## Metal Junction Box Grounding Instructions

<b>Bulletin Type:</b>	RCL	<b>Publication Date:</b>	July 2021
<b>Bulletin #(s):</b>	21V-449	<b>Make(s):</b>	Jayco
<b>Job Code(s):</b>	9901568	<b>Model(s):</b>	White Hawk
<b>Flat Rate(s):</b>	.50 / Hour	<b>Model Year(s):</b>	2021

<b>Incident:</b>	Metal junction box was not grounded
<b>Affected Units:</b>	2021 Jayco (4K) White Hawk M14K0262-M14K0304
<b>Parts List:</b>	<b>Parts List: (Purchase locally)</b> - MN cable (Copper Wire)
	<b>Parts Kit Contents: None</b>
<b>Misc. Tools &amp; Supplies:</b>	- Flathead Screwdriver - Wire Pliers/strippers

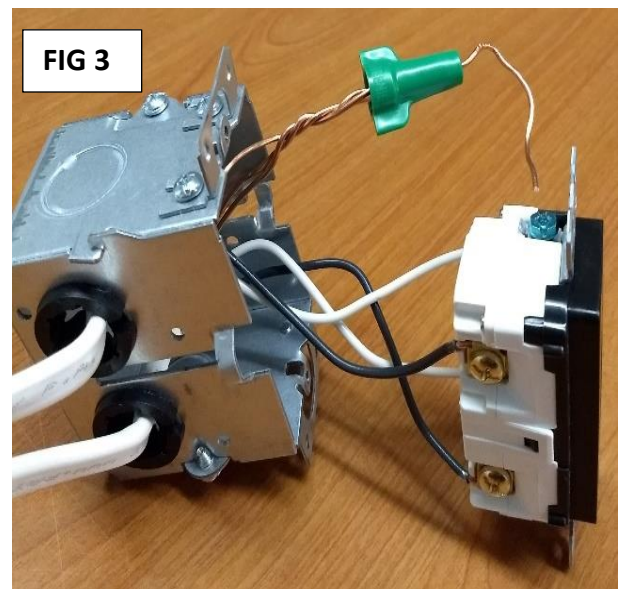
1. Disconnect unit from the 120V power source
2. Locate metal junction box with a GFCI receptacle at the kitchen.
3. Remove faceplate and receptacle (Fig. 1) to expose wires.

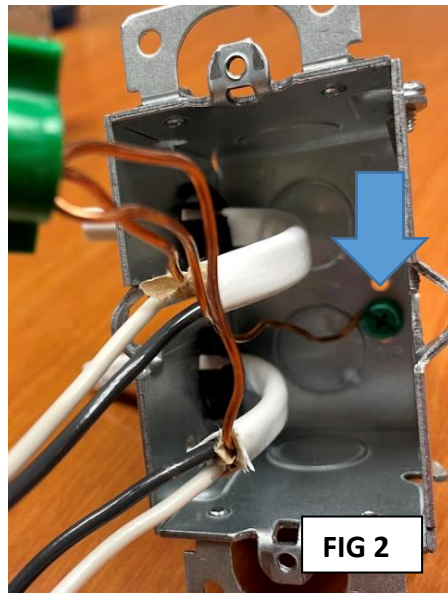
4. Install and secure a separate bare ground wire of sufficient length at the green ground screw (Blue Arrow) in the metal junction box (fig 2).

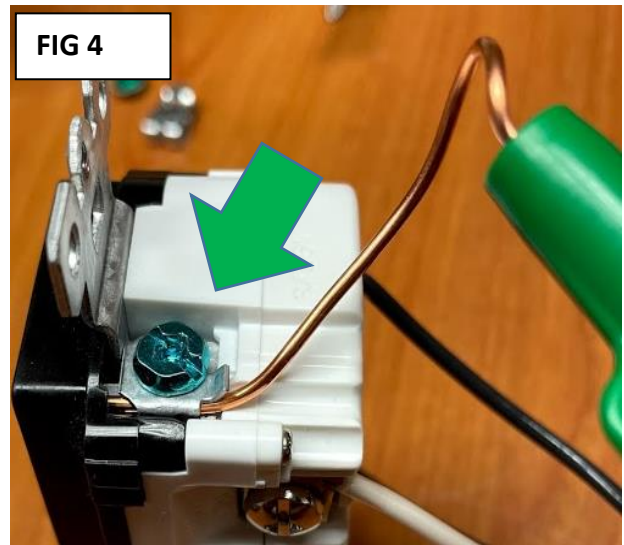
5. Connect all ground wires together with green wire nut. Ensure the bare ground wire attached to the box passes through the hole in the top of the green wire nut (fig 3).
6. Connect the bare ground wire coming through the top of the wire nut to the green ground screw (Green Arrow) on the GFCI receptacle (fig 4).
7. Insert wires back into the metal junction box.
8. Secure GFCI receptacle and outlet face plate to junction box.
9. Turn power back on and validate function of the GFCI receptacle.
10. Repair is complete.
